INDESIT company

Model type:
TAN2S

Commercial code:
F034169

Technical Documentation guidelines

51420c0 Exploded views

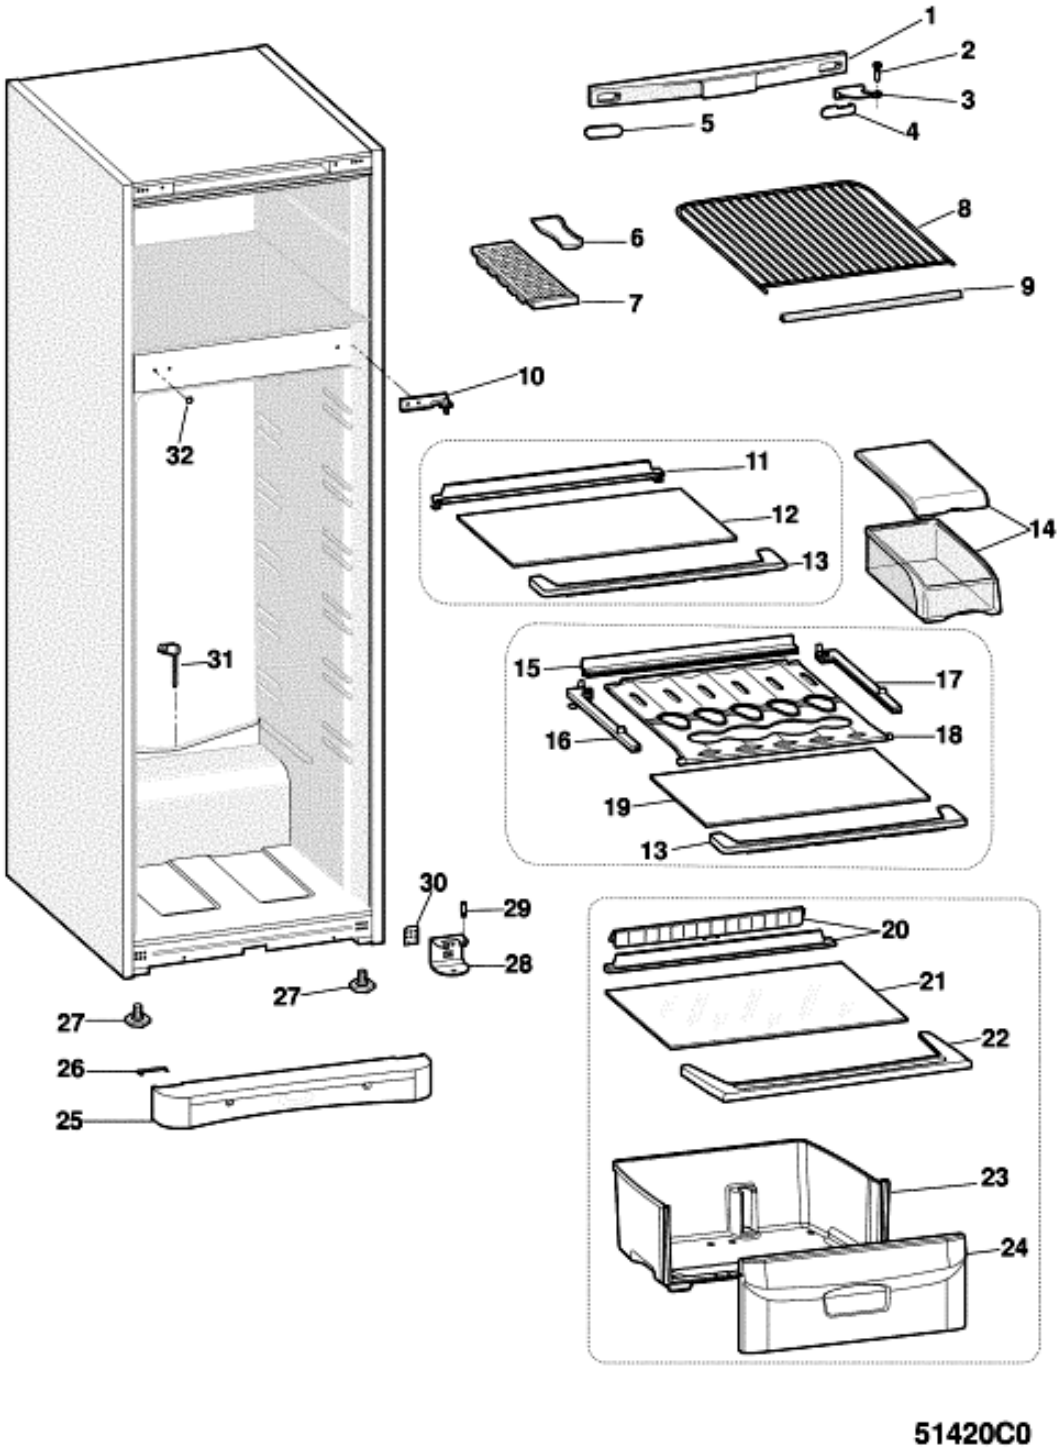
n2510j00: SUBSTITUTION LOWER HINGE PIN

In order to make better the assembly and to prevent an accidental unscrewing of lower hinge pin with consequent falling down of the door, original pin has been substituted by another one longer.

C00017658 (13.5mm) --> C00259768 (21mm) --> C00281425 (23mm)

For quality issues on interested models is managed only the last one C00281425 (23mm).

51421m0 Exploded views

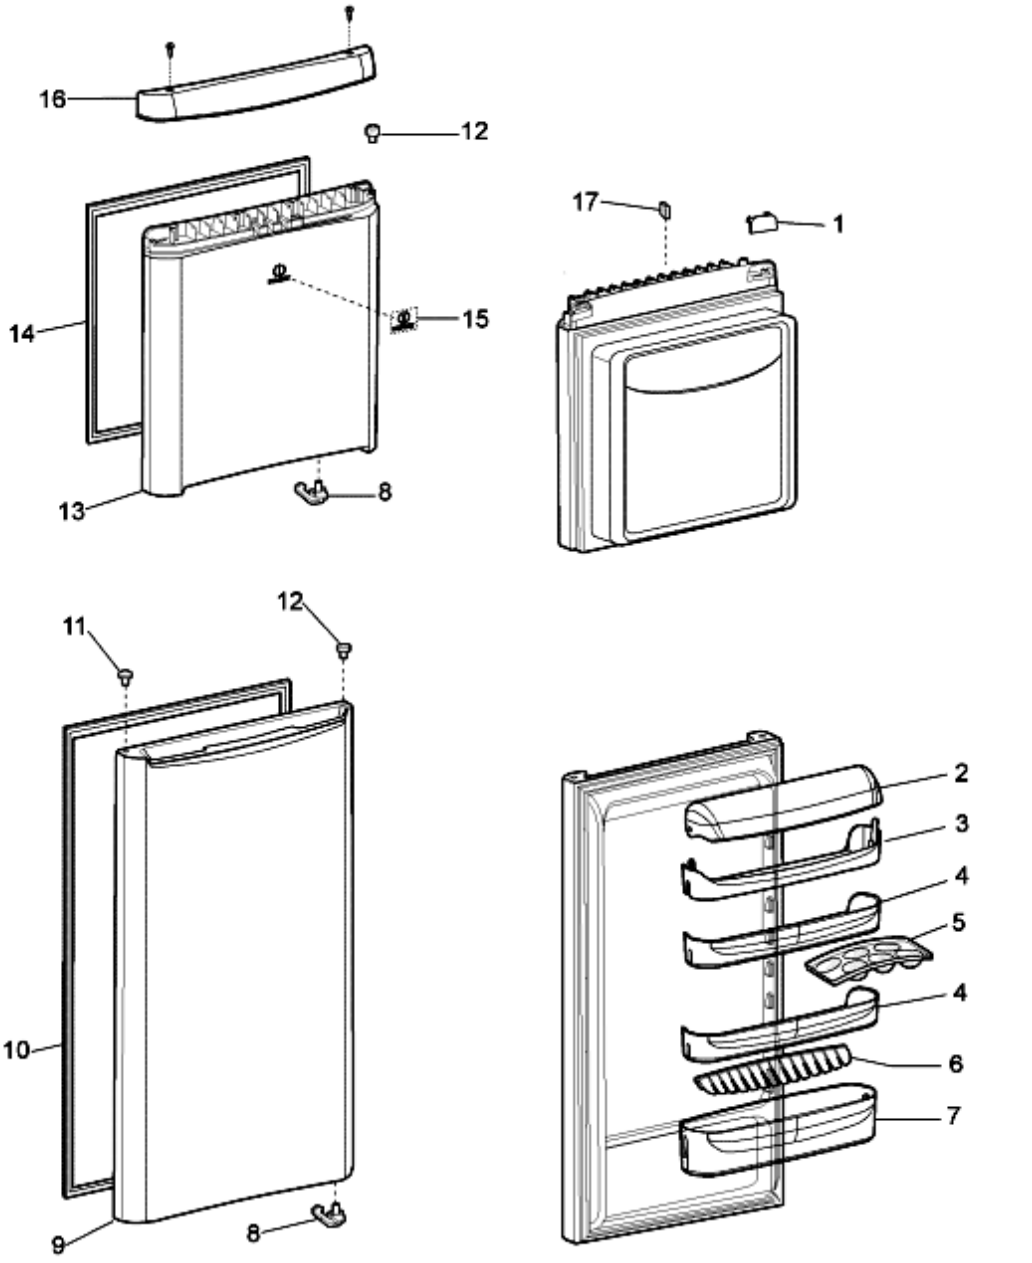
n2507b01: Color change on inner door upper heading

From s/n 70129.0001 (January 2007) on teak – inox – silver Indesit models has been introduction in production a new white inner door upper heading / white hinge blanking plate.

When replacing the door in the products produced before the modification replacing also the brown hinge blanking plate (for teak versions), grey (for silver version), aluminium (for inox versions) with the white.

n2511b02: ELIMINATION COVER FOR UPPER DOOR SHELF-INTERNAL ACCESSORIES RESTYLING

Cover for upper door shelf has been eliminated. The upper door shelf has been standardized with the middle one. Subsequently has been standardized with transparent internal accessories instead of those in light blue colour once stock has depleted.

The spare part code of the door remain the same.

5142260 Exploded views

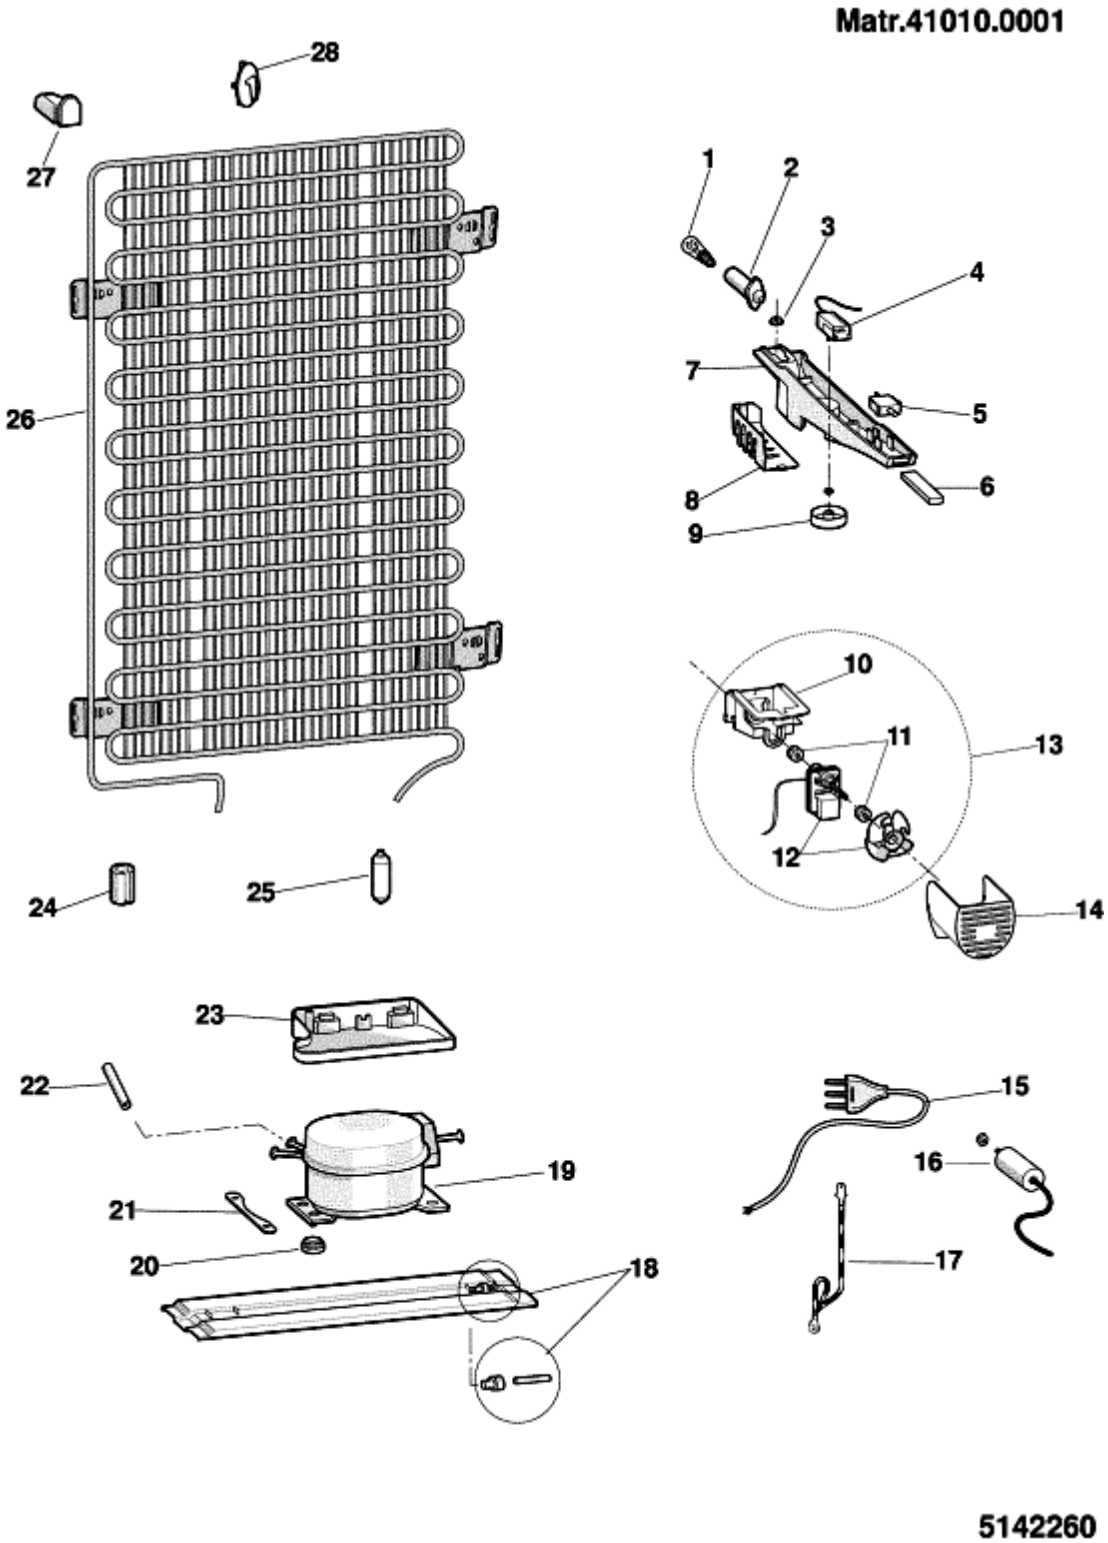
n1025101: Disappearing bulb thermostats (warning!)

The apparatus that provide for the thermostat to be threaded into a small tube located inside the fridge cabinet are noted as versions with "disappearing bulbs".
The bulb must be inserted for a length equal to the position indicated on the colored ribbon (small mark) which confirms the correct position of the bulb in the evaporation area, otherwise causing the poor performance of the apparatus.
Therefore in cases of thermostat replacement it will be necessary to reset on the new, if missing, the same small mark position and always check that the thermostat bulb is completely devoid of the sheath so as to ease its insertion.
The entrance of the small tube, placed in the thermostat container, is protected by a perforation cover in order to avoid the formation of condensation. The perforation cover was initially situated externally and could be substituted with putty or silicone.
For the models with disappearing bulb thermostats, the spare parts are inclusive of the small colored marker,

however check that its position corresponds to that on the thermostat that will be replaced.
The spare part description always notes the position of the small marker in millimeters as well as the thermostat initials.

n1025135: Thermostat box on Indesit/Ariston Opera-60 refrigerators (low A.T. +16°C)

As of July 2003, two new "Low ambient temperature thermostat box kits" have been introduced as spare parts for Ariston Opera-60 and Indesit 2000 - 2002 - 2003 range refrigerators with Giugiaro thermostat box (075646).

The kit must only be used to solve freezer performance problems caused by an ambient temperature below +16° C.
This innovative kit features a DIODE, activated by means of the luminous switch, which makes the thermostat box lamp turn on. It must be activated when the ambient temperature falls below +13°C (closed contacts: see the wiring diagram that comes with the kit).
The heat produced by the lamp activates the thermostat, thus ensuring regular operation of the appliance.
When replacing the thermostat box, no component can be reused (including the wiring).
The kit wiring has pin terminals for connection to the terminal block on the compressor; some modifications may be required for other solutions.
Given below is the list of kit items available as spare parts:
